ANN ARBOR HISTORIC DISTRICT COMMISSION

Staff Report

ADDRESS: 213 South Main Street, Application Number HDC15-247

APPLICATION: The applicant seeks HDC approval to construct a 260 square-foot roof deck and rooftop stair enclosure. The 5'-1-1/2" wide x 22-5-1/4" long roof access penthouse will be located on the north center edge of the roof, with the deck on the west end toward South Main Street.

ROOF PLAN

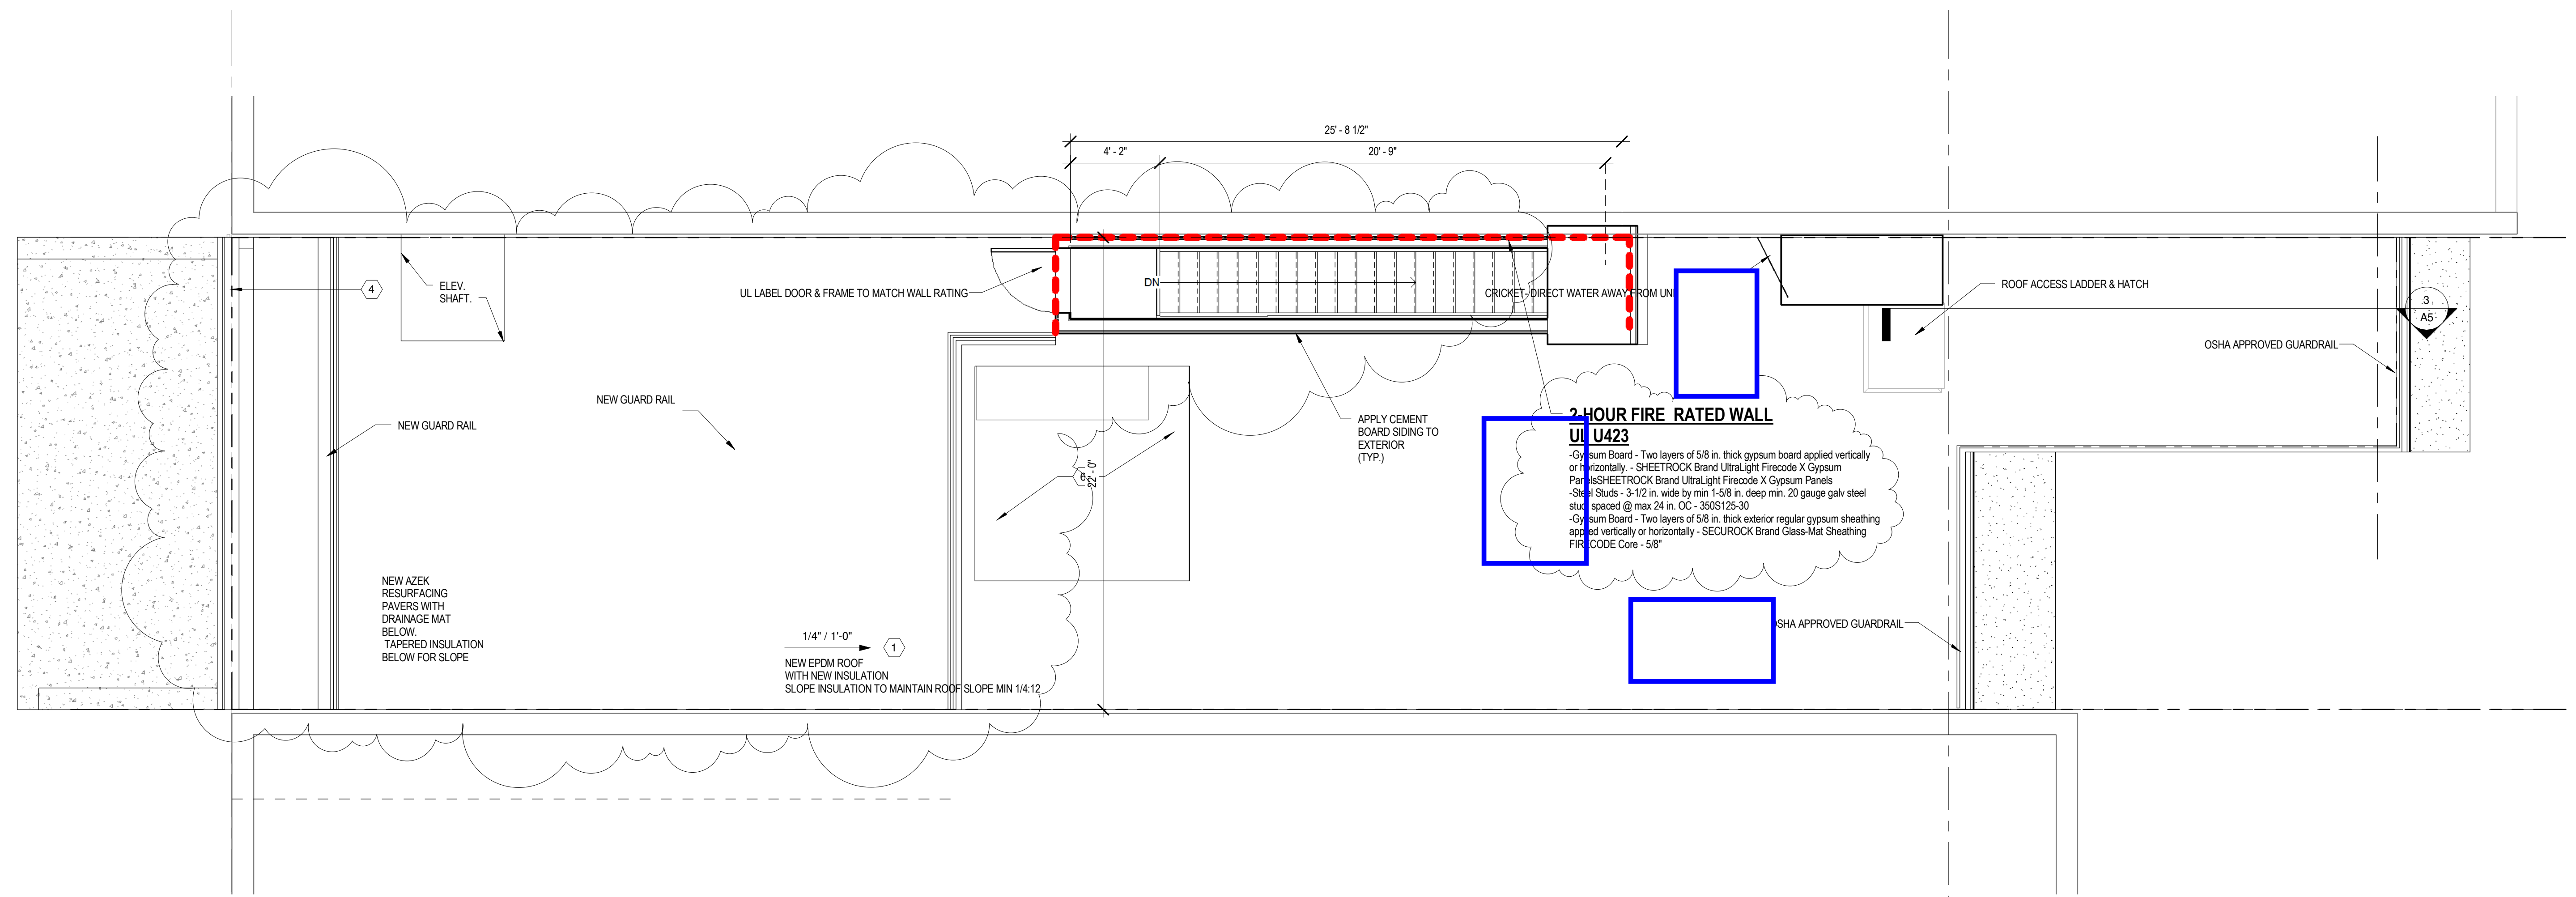
1. The proposed roof deck is reported by the applicant to be 260 square feet on the application, and 238 square feet and 14' x 17' in a follow-up email. The deck looks larger on the drawing, closer to 22' x 25'. It would be constructed of Azek resurfacing pavers, with a 48" tall guardrail. The deck is set back 5' from the 42" parapet on the west edge of the roof. The stair enclosure has an approximately 5' x 29' footprint, and is located on the north edge of the roof, about 35' behind the front parapet. The stair enclosure is clad in Hardie Panel, with a low pitched shed roof. The door to the stair faces west, and there are no windows. Optional skylights are shown, which staff has no objection to.

EXTERIOR ELEVATIONS

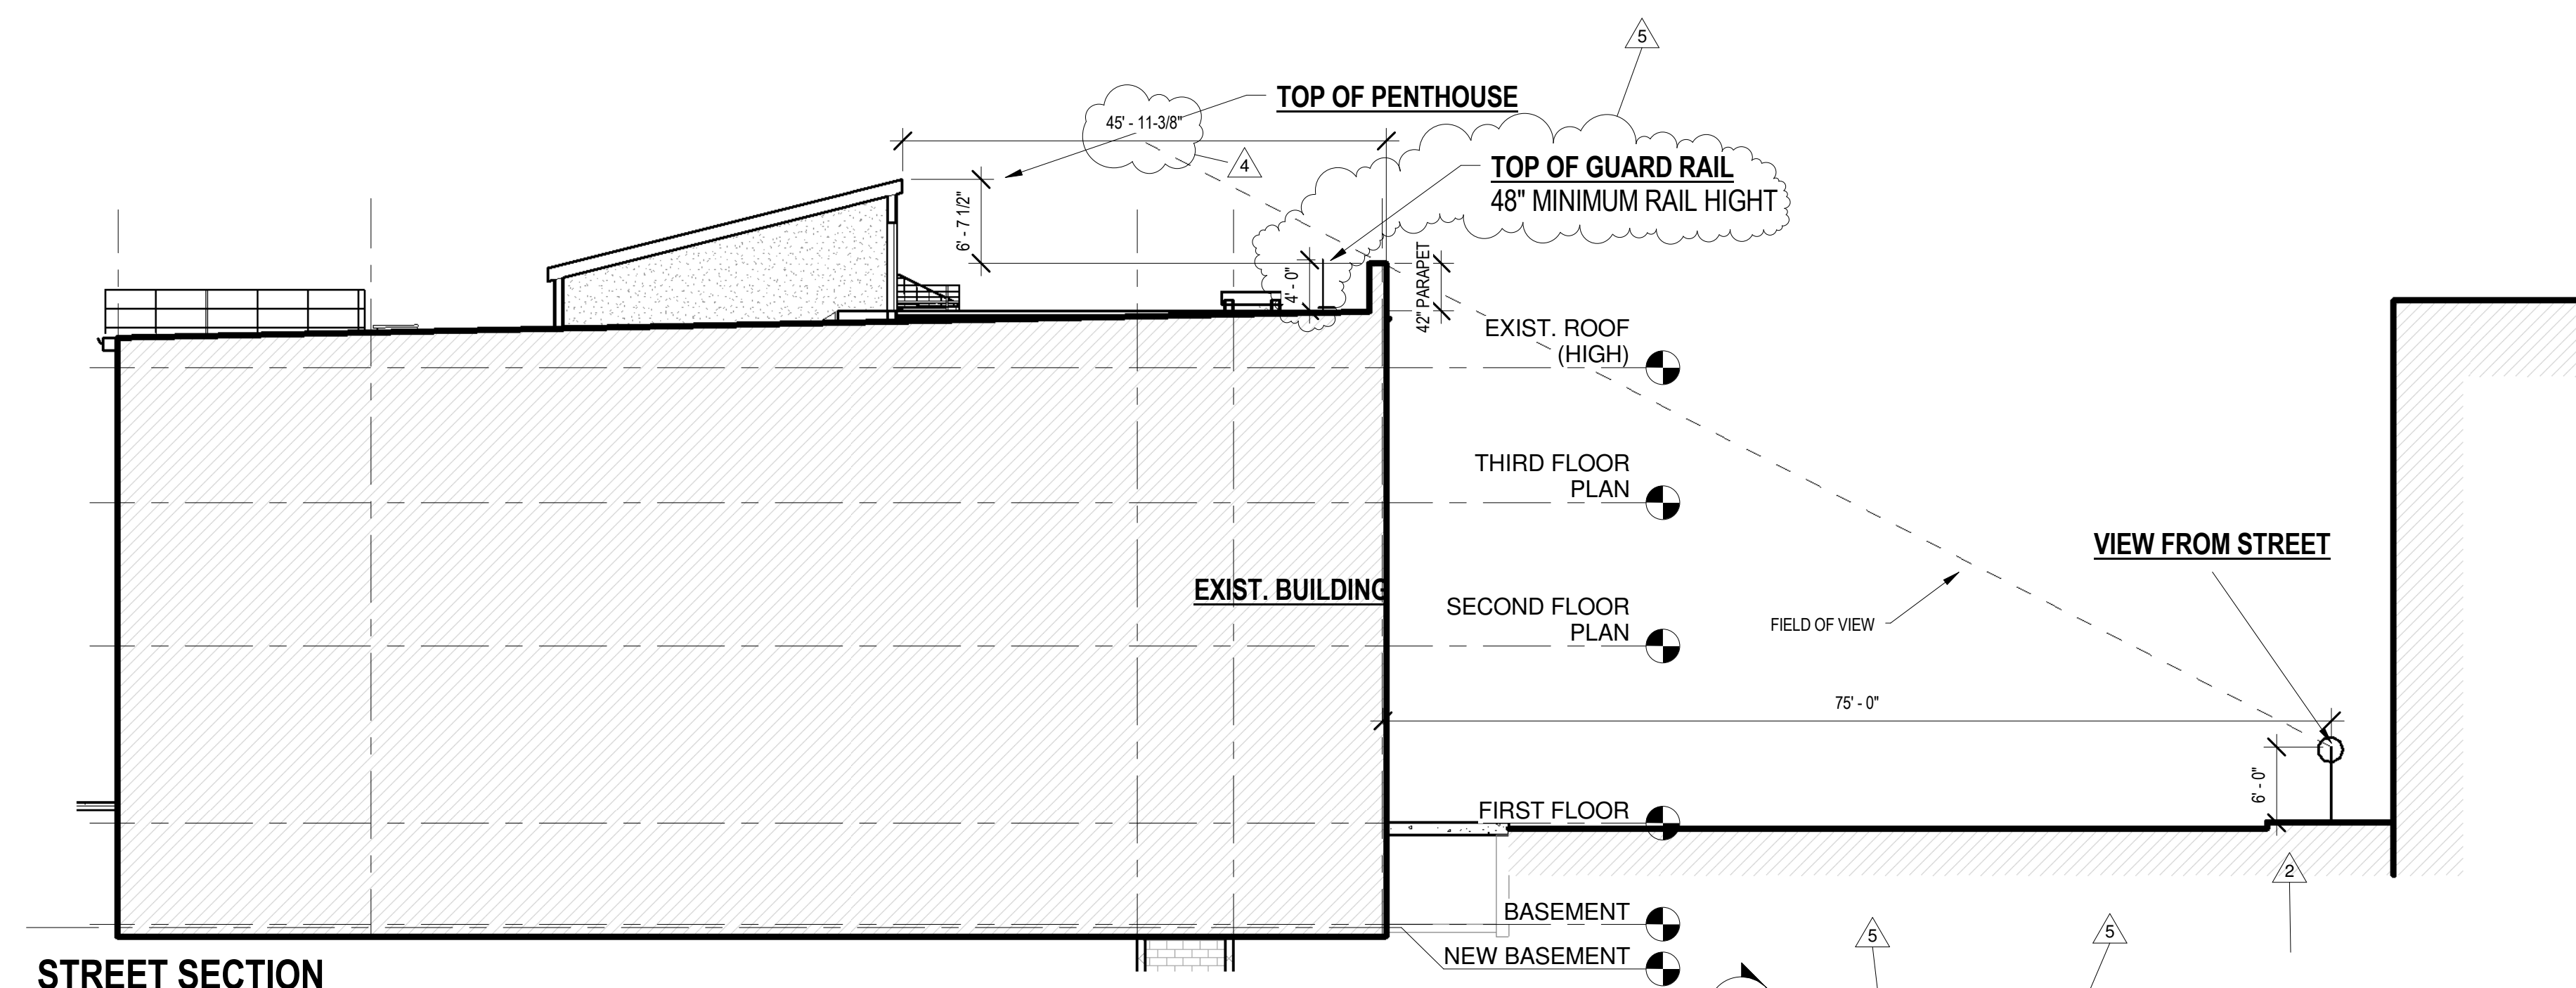
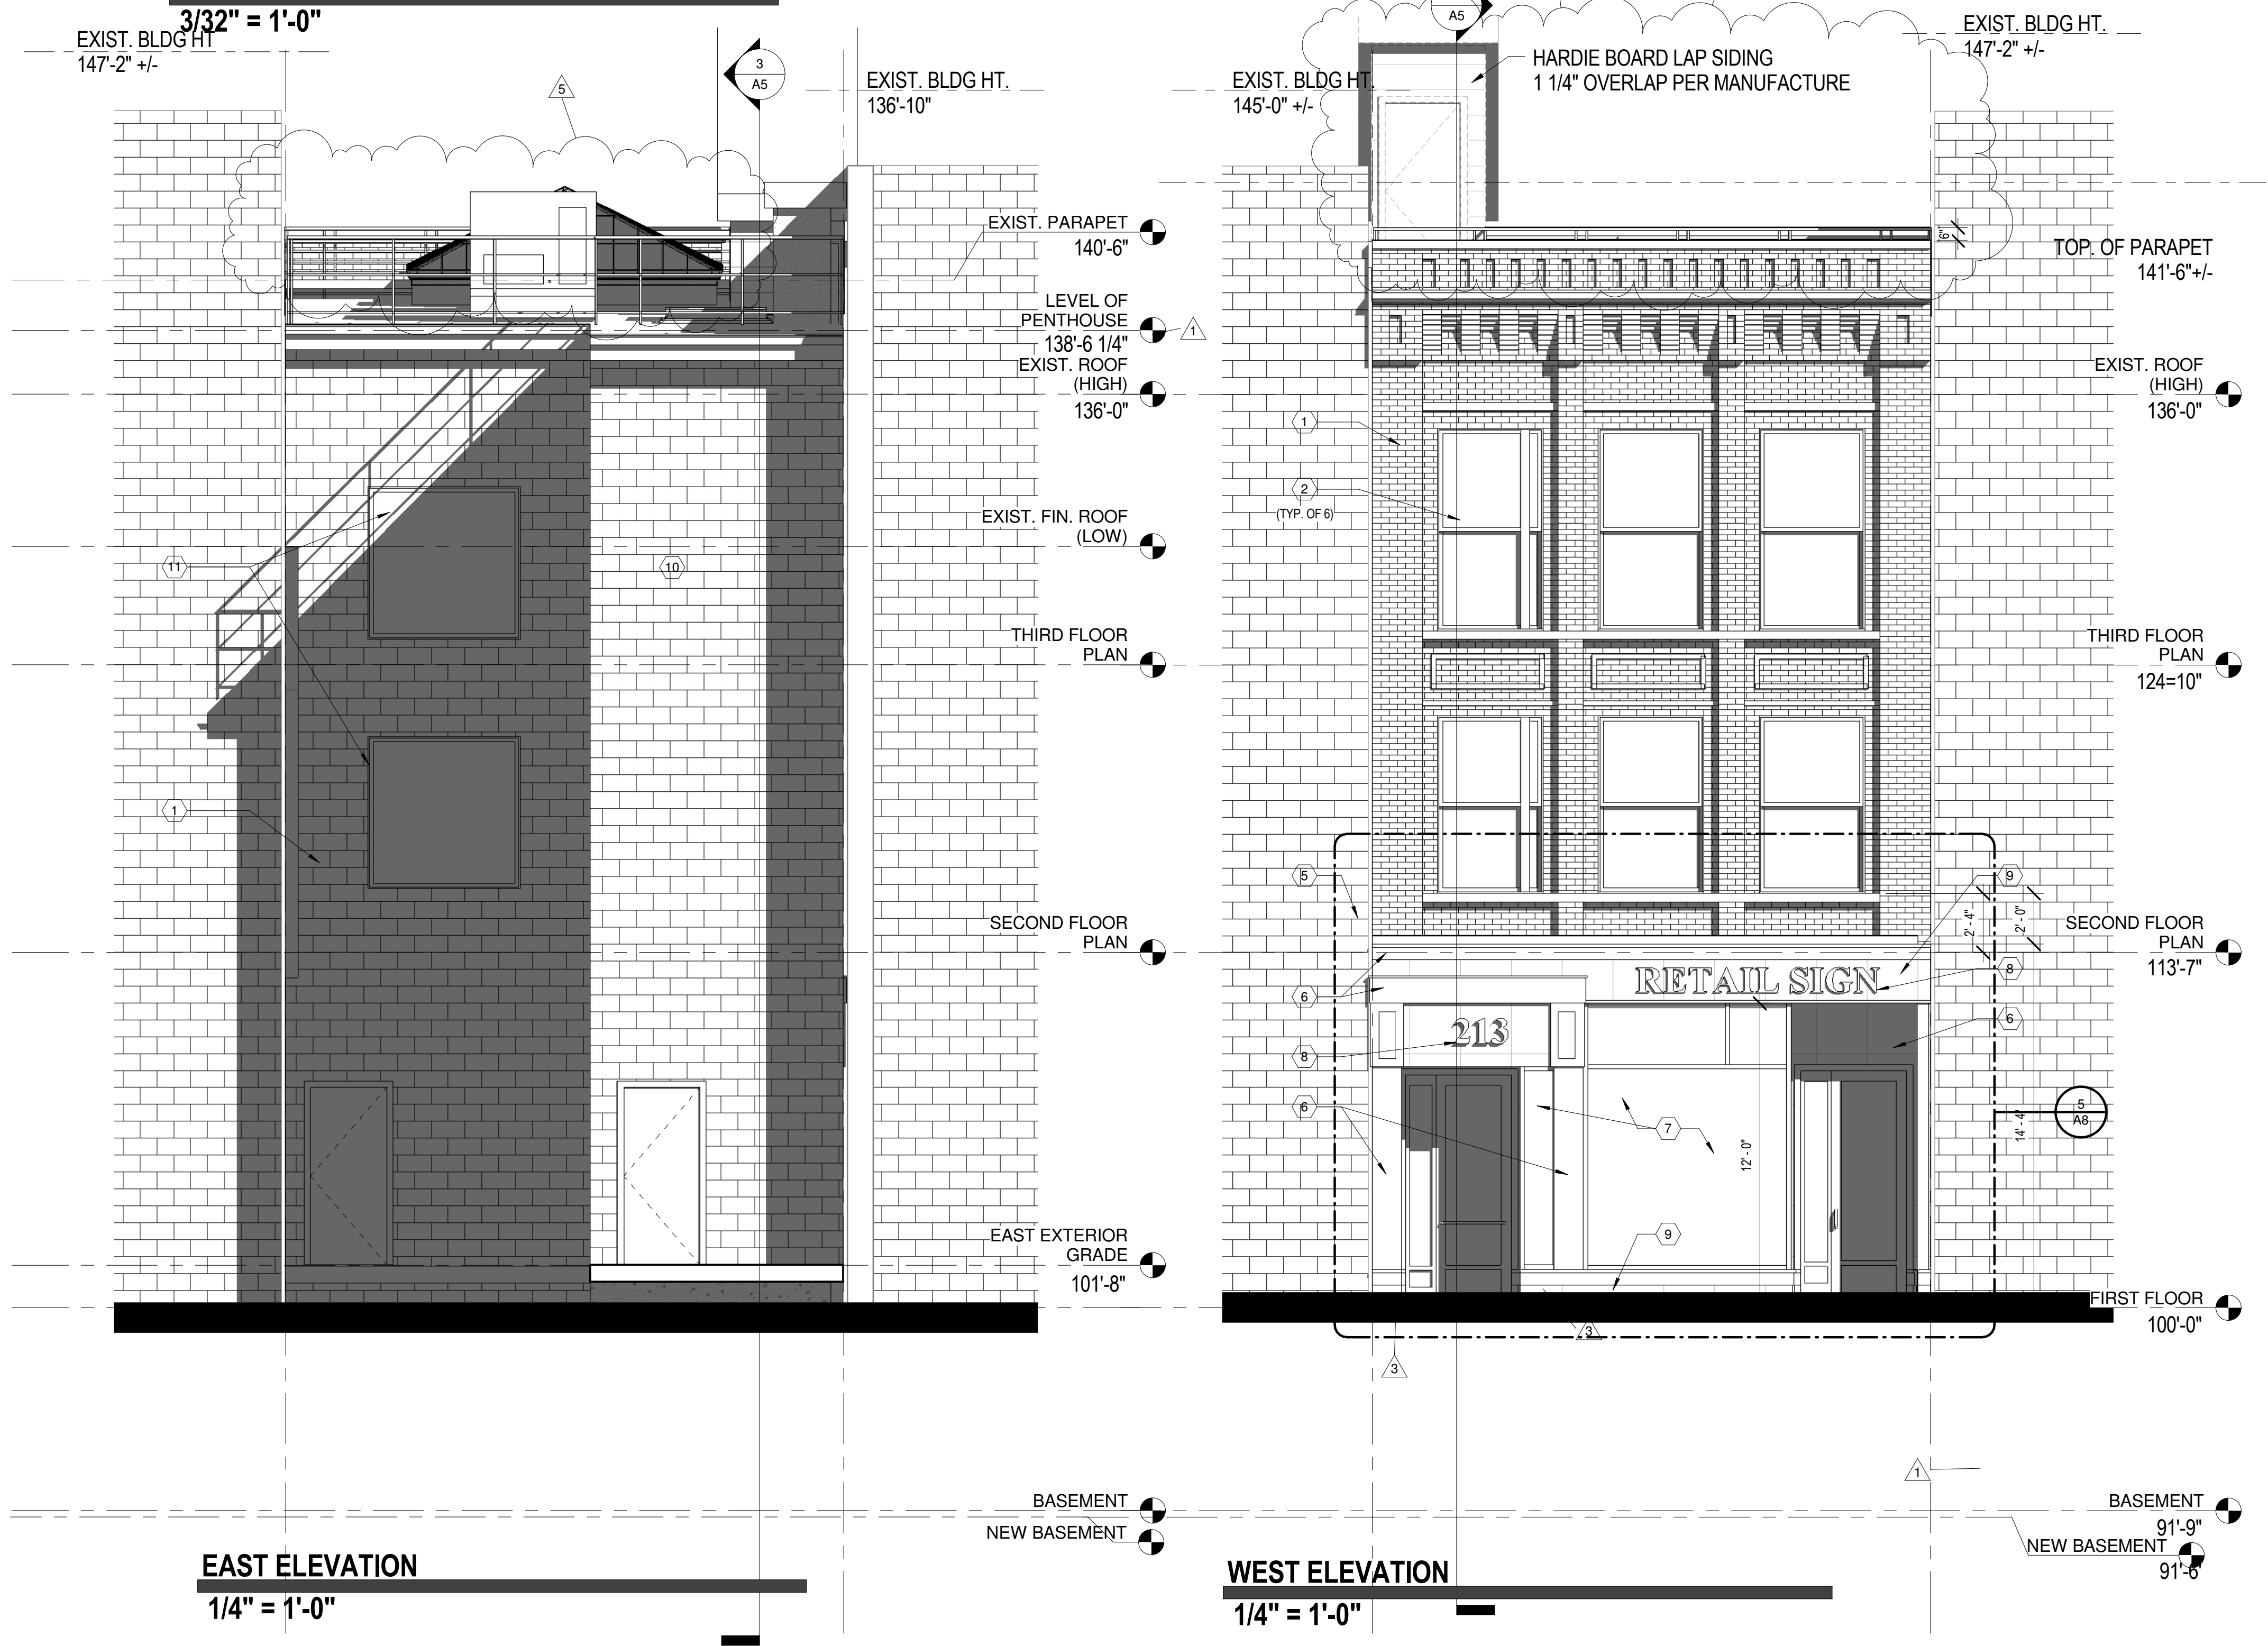
2. Per two-dimensional drawings provided, the work will not be visible to a person standing across South Main Street.
3. Per the SOI *Guidelines* for additions, no character-defining features of the historic building are obscured, damaged, or destroyed by this proposal. The stair enclosure is set back from the street frontage in order to minimize the line of sight from pedestrians on Main Street. The materials and methods of construction clearly delineate what is historic and what is new.
